Project	IEEE 802.16 Broadband Wireless Access Working Group < http://ieee802.org/16 >	
Title	MBS Refinement	
Date Submitted	2005-04-28	
Source(s)	Yeongmoon Son, Hyunjeong Kang, Jungje Son, Panyuh Joo Samsung Electronics Co. Ltd. Yongjoo Tcha, Seong-Choon Lee KT Corp.	Voice: +82-31-279-5845 FAX. : +82-31-279-5130 ym1004.son@samsung.com yjtcha@kt.co.kr
Re:	IEEE P802.16e/D7-2004	
Abstract	This contribution proposes Enhancement and Clarification of MBS	
Purpose	Discuss and adopt this contribution	
Notice	This document has been prepared to assist IEEE 802.16. It is offered as a basis for discussion and is not binding on the contributing individual(s) or organization(s). The material in this document is subject to change in form and content after further study. The contributor(s) reserve(s) the right to add, amend or withdraw material contained herein.	
Release	The contributor grants a free, irrevocable license to the IEEE to incorporate material contained in this contribution, and any modifications thereof, in the creation of an IEEE Standards publication; to copyright in the IEEE's name any IEEE Standards publication even though it may include portions of this contribution; and at the

Figure 1. Dynamic Service Addition procedures for several MBS services

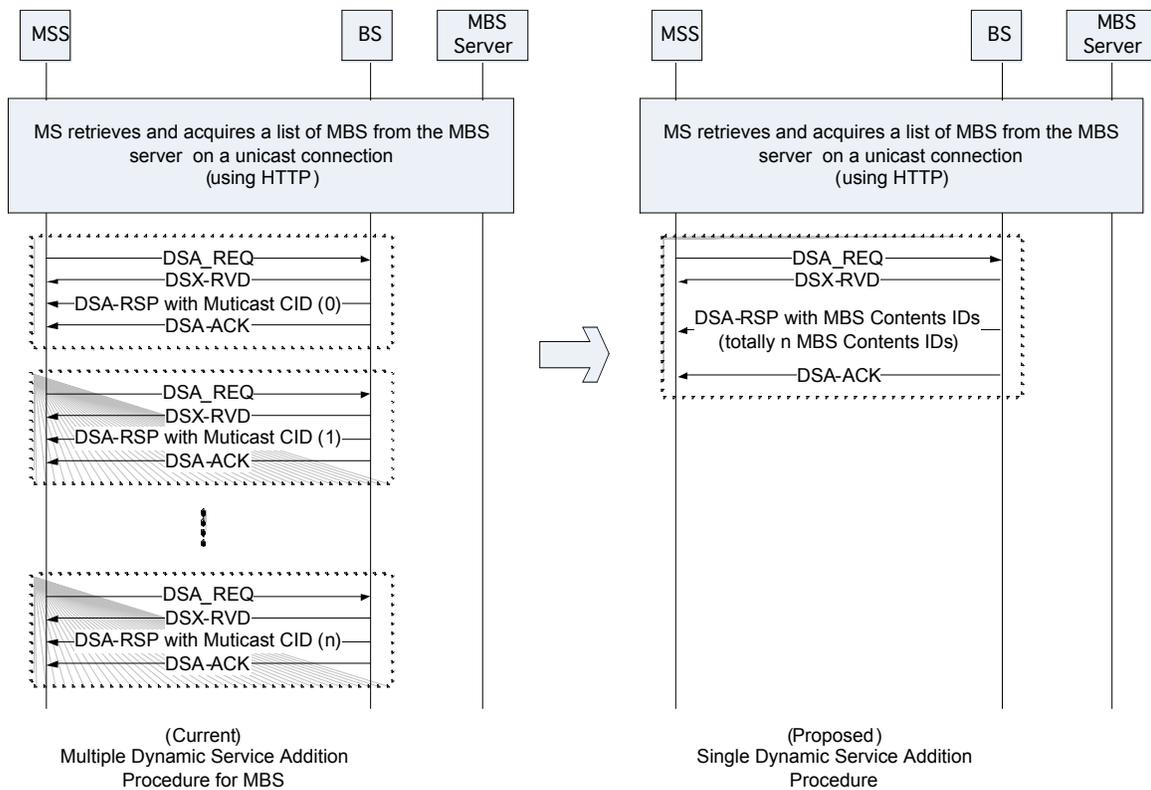
In Multicast and Broadcast Service (i.e. MBS) of IEEE802.16e, when MS is registered to certain BS, it shall perform a Dynamic Service Addition (DSA) Procedure as described in 6.3.13.1 in order to get service of MBS from the BS. And according to current MBS scheme, each MBS contents(or channel) shall have a different connection identifier. Therefore, if MS wants to receive several MBS services from BS, it shall perform DSA procedures as many times as the number of MBS contents which MS wish to receive, as shown in the left side of figure 1. It can cause inefficient bandwidth consuming due to the multiple DSA procedure and the long time for complete establishment of MBS services. But in many cases, since MBS contents may not have different service characteristics, if we have a identifier for each service in same service flow, we do not need to use different identifier such as connection identifier and service flow identifier.

We propose the 'logical channel ID' used to distinguish each MBS contents which have the same service flow. A logical channel ID is allocated to MBS contents in order by MBS Contents Identifier TLV encoding included in DSA-RSP message. We also propose the new MBS_DATA_IE which includes the logical channel ID.
